JIM WHELAN
BOARDWALK HALL

SUBJECT: JWBWH STOREFRONT RENOVATION & DOOR REPLACEMENT– ADDENDUM #2

JIM WHELAN BOARDWALK HALL STOREFRONT AND DOOR REPLACEMENT DESIGN

ADDENDUM #2

A-101

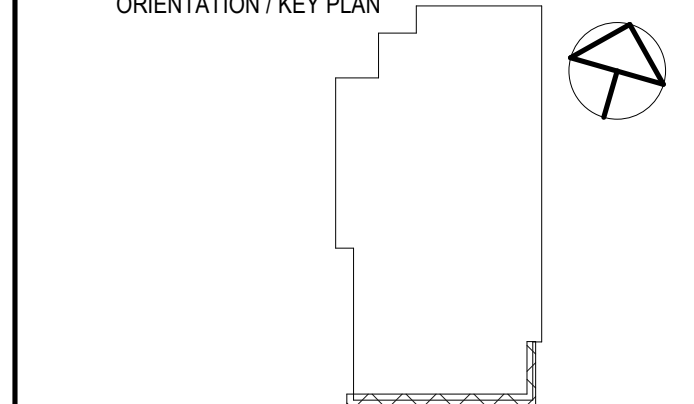
1. **Q:** Will the new windows above the ceiling on the interior side need to be tinted to match existing?
A: *Windows above the ceiling will not be tinted but will have removable opaque film to match the existing window film at SO1 and installed from the exterior. Provide sample for Architect & Owner Approval.*

1. A-100:
 - a. 1/A-100: First Floor Construction Plan indicates locations of temporary walls and phasing of construction work.
2. A-101
 - a. 4 & 5/A-101: Storefront Elevations indicate location for new removable opaque window film to be installed at upper windows. Contractor to provide samples for Architect and Owner approval.
